#### 555-2015 ADDENDUM 3

# REQUEST FOR PROPOSAL FOR PROFESSIONAL CONSULTING SERVICES FOR EASTERN CORRIDOR STUDY

Figure 7: Conceptual Project Workflow (Amended)

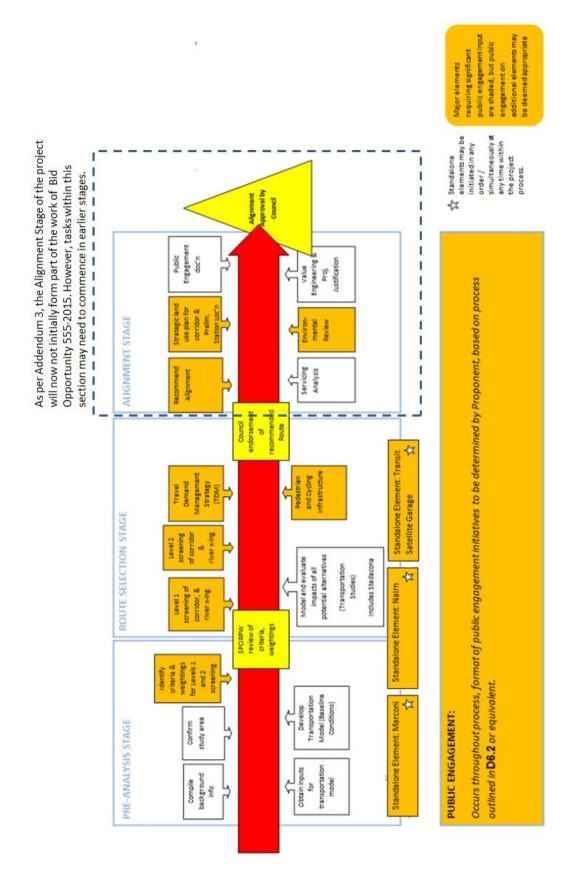
Revise Figure 7, page 21 of 42. See Page 3 of 5 of Addendum 3.

Revise: D6.4(a)

It is anticipated that the project work be divided into two primary stages (after the preanalysis stage) as shown in Figure 7, with the majority of tasks completed in two stages separated by a Council Endorsement period:

- (i) Route Selection Stage / Stage RS: Options are created, evaluated, and a recommended route is selected for approval by Council (D6.4.)
- (ii) This stage will also require the undertaking of a functional design study for Louise Bridge / Stadacona Extension that will develop a recommended plan for Council approval.

- (iii) The Transit Satellite Garage (D6.4.12) will be completed to a Schematic Level of Detail estimate initially. (No change to the requirement for this element)

- (iv) Assume 12 months, commencing at Award Date for items (i) to (iii), above.
- (v) Council Approval: a two to four month period for Council to consider and approve the recommendations for this infrastructure.

- (vi) Alignment Stage / Stage AL: Recommended route is analyzed in detail. (D6.5.) and schematic (preliminary) design of Louise Bridge and the Stadacona Extension. Assume a minimum of 12 months following Approval by Council.

- (vii) Phase II, the P3 business case and value for money (VFM) analysis area would take place in tandem with D6.4.(a)(vi)
